CITY OF VANCOUVER
COMMUNITY SERVICES GROUP

DEVELOPMENT PERMIT STAFF COMMITTEE REPORT
MAY 18, 2011

538 WEST 7TH AVENUE (COMPLETE APPLICATION)
DE414388 - ZONE C-3A

GROUND FLOOR PLAN

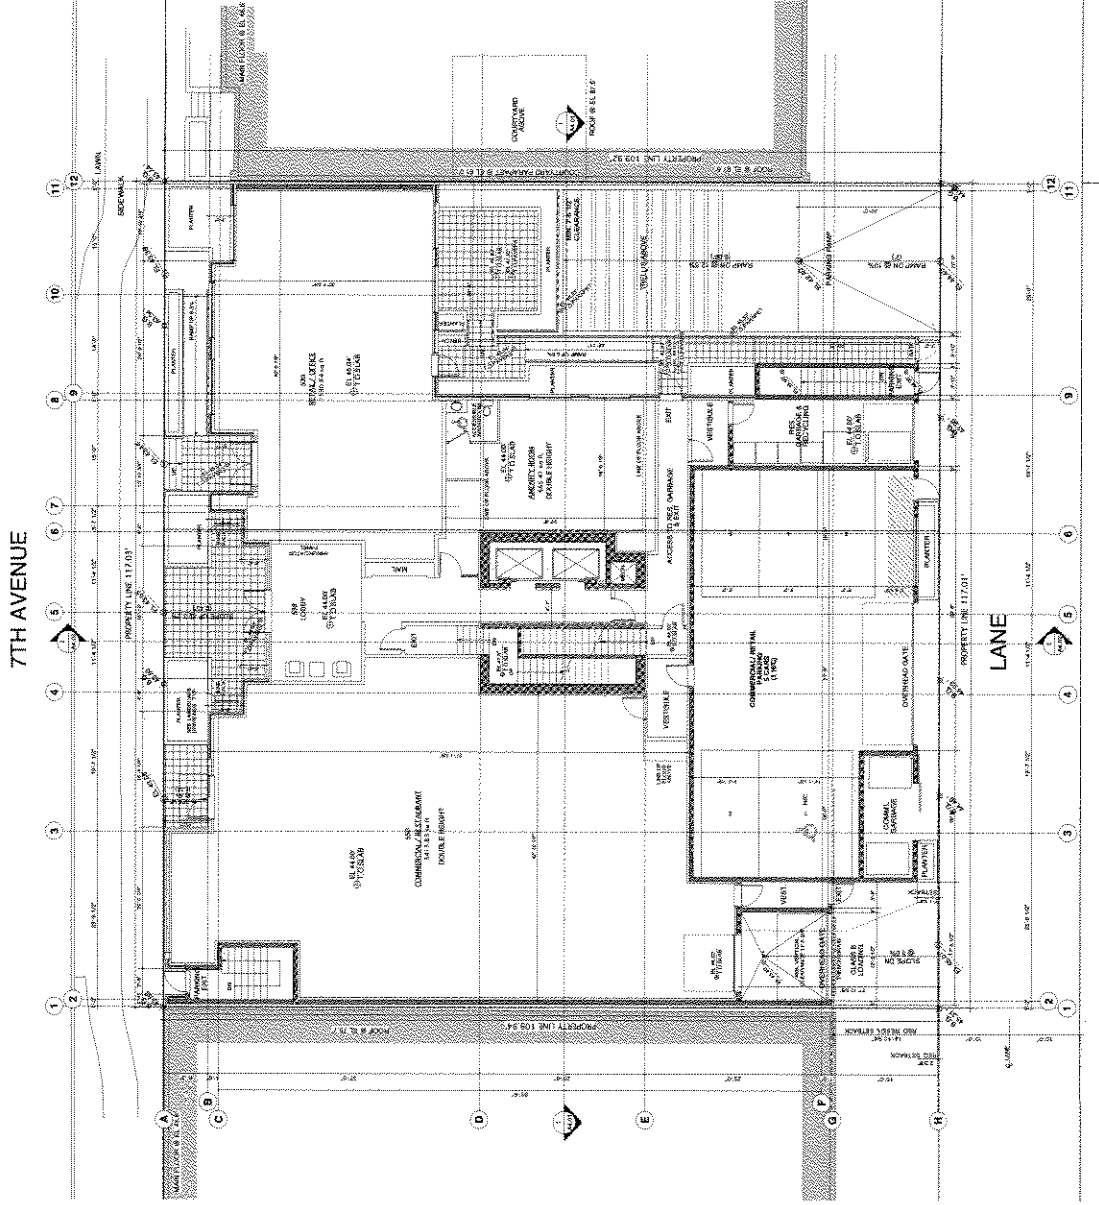
- 1.2.1 lower the entry level of the commercial unit #530 so it is level with the grade of the sidewalk;

Note to Applicant: Entry doors should be at sidewalk level to allow good connectivity to the street, avoiding physical and visual barriers between the street and the commercial frontage. Remove or internalize exterior ramps and stairs. (See Design Condition 1.2.3) In consultation with the City Engineer, consider further modifications to the parking ramp slope to enable a lower floor slab.

- 1.2.2 increase the floor to floor height of the ground level commercial unit #530, by approximately 5 ft (1.5m);

Note to Applicant: The minimum final floor to floor height should be approximately 16 ft (4.87 m). The extra height can be achieved by removing or relocating 2nd floor residential units.

- 1.2.3 remove all above grade structures between the building frontage and the property line;

Note to Applicant: The ramp structure and large planters create physical and visual barriers between the street and the commercial frontage. Planters need to be in ground and level with the sidewalk, lowering the parking slab as required. (See Landscape Condition #A.1.14)

- 1.2.4 reduce the depth of the entryway for commercial unit #530, while maintaining a smooth transition between varying building setbacks of the adjacent context;

Note to Applicant: The recessed entryway appears too private and at odds with the public realm objectives of C-3A Design Guidelines for commercial uses.

- 1.2.5 extend and enlarge the windows of the commercial unit # 530; and

Note to Applicant: The commercial frontage needs greater transparency as seen from the street and more opportunities for greater connectivity with the

public realm, providing an interesting and varied pedestrian experience. Commercial windows should be as large and transparent as possible, avoiding small residential sized windows. Consider incorporating operable windows to allow terrace seating area at the street edge.

- *Floor elevation of the commercial unit #530 and exterior pedestrian ramp:* The entry floor elevation of the commercial space should be level with the sidewalk grade not requiring stairs or ramps for entry access. Staff would recommend the stairs and ramp are internalized or to consider lowering the floor elevation.

- *Floor to floor height of the commercial unit #530:* At just over 11 ft floor to floor, this space is considered low for commercial uses, especially retail. Staff would recommend a minimum height increase to the floor to floor of approximately 5 ft. for a total increase to the floor to floor height of approximately 16 ft, without any increase to the overall building height.

- *Large in ground planters and ramp structure:* These large bulky structures interrupt a contiguous ground plane and create physical barriers between the street and the commercial frontage. (See also Landscape Condition A.1.15)

- *Deep entries:* Staff would recommend that small deeply recessed commercial entryway for commercial unit #530 be modified for a better street interface.

- *Window Expression:* The windows of the commercial unit #530 are considered too small and residential in expression and staff would recommend these be modified to better suit commercial uses.

10TH FLOOR PLAN

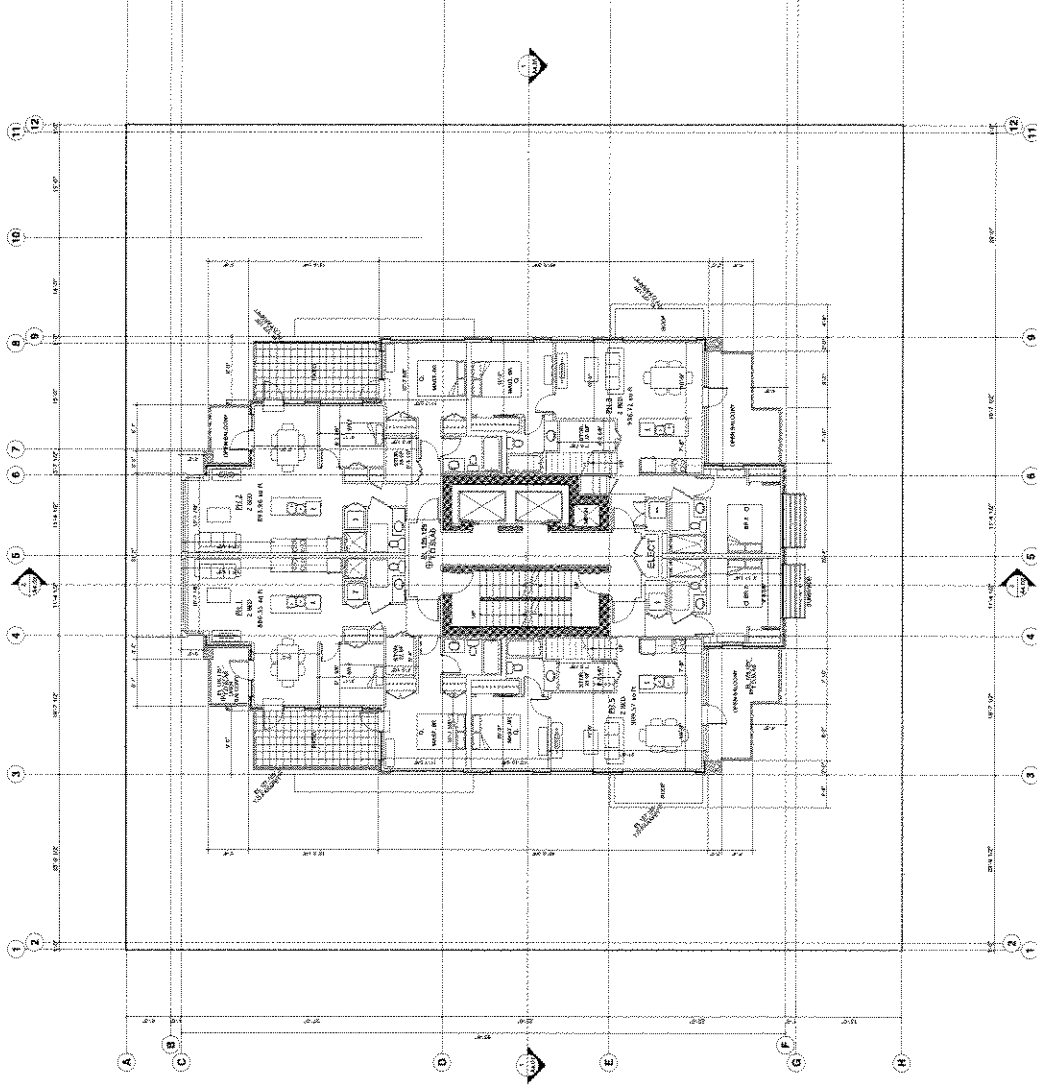
- 1.3.1 improve neighbourliness, reducing and pulling back the roof top terraces from the parapet edge to avoid direct overlook of the open balconies below at the 10th floor level; and

- 1.3.2 add weather protection for the open 10th floor balconies.

Project Title
 Landscape plan
 Ground Level

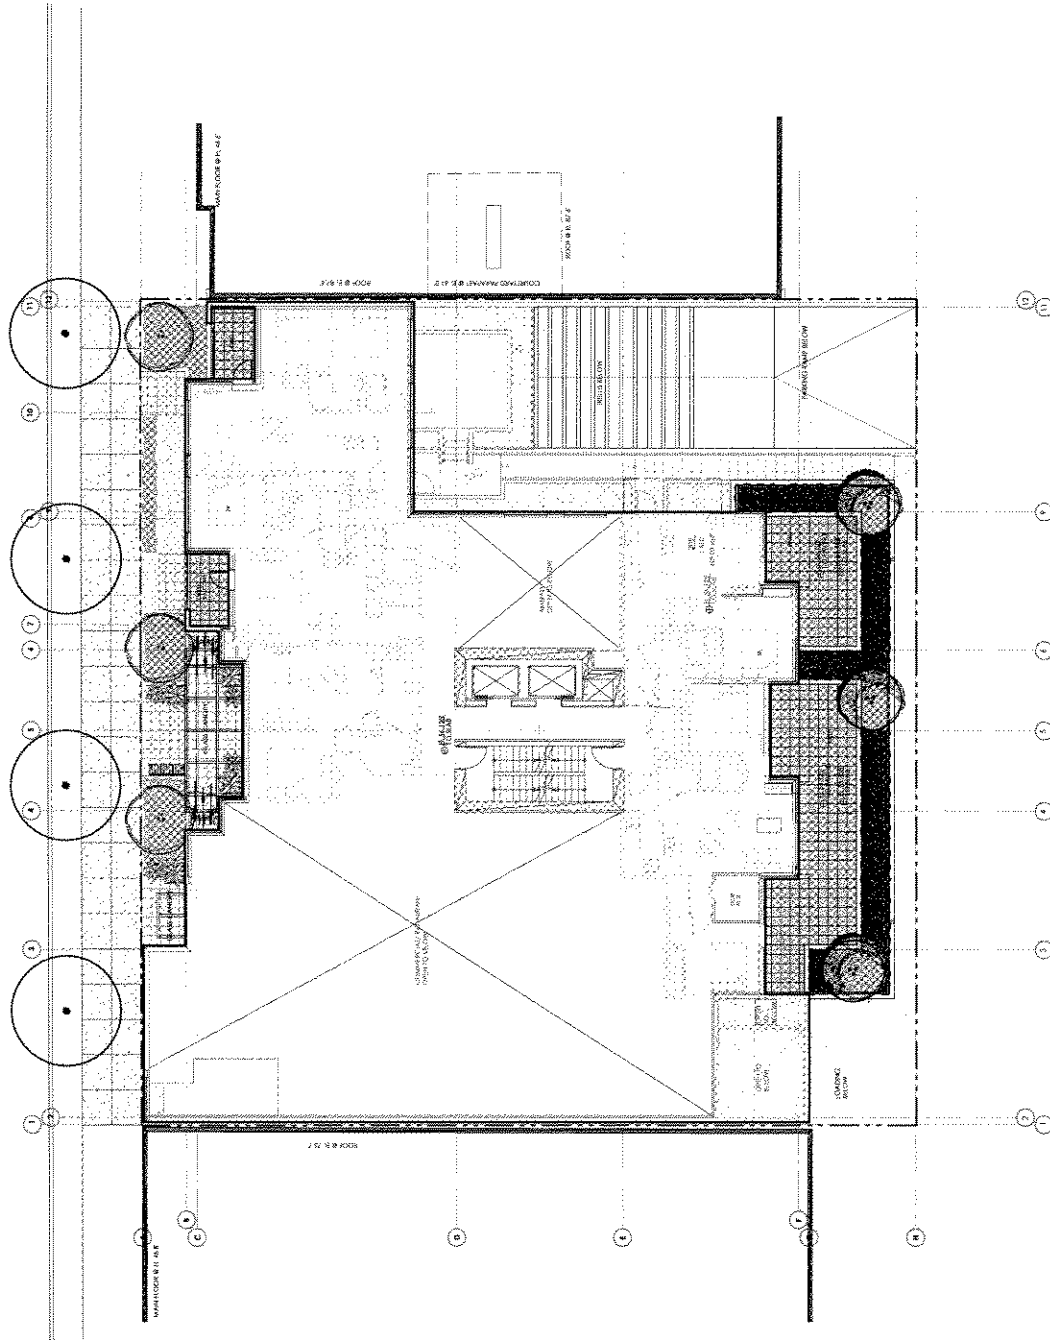
The Panel thought the planters seemed like a barrier in the public realm and should be moved to mask the ramp. One panel member suggested the applicant look at the size of the trees and the species as some of the trees might get too large for the space. The west deck seemed chopped up and other ways should be sought to improve privacy. A Panel member suggested opening up the amenity deck to the urban agriculture and another Panel member suggested greening the roof deck. As well a number of Panel members thought the tower roof could be made useable with the addition of an outdoor amenity or other uses.

A.1.13 provision of a more substantial (layered) shrub planting within planters at the lane edge to soften the landscaping as a visual amenity at the lane edge (illustrated on the Landscape Plan);
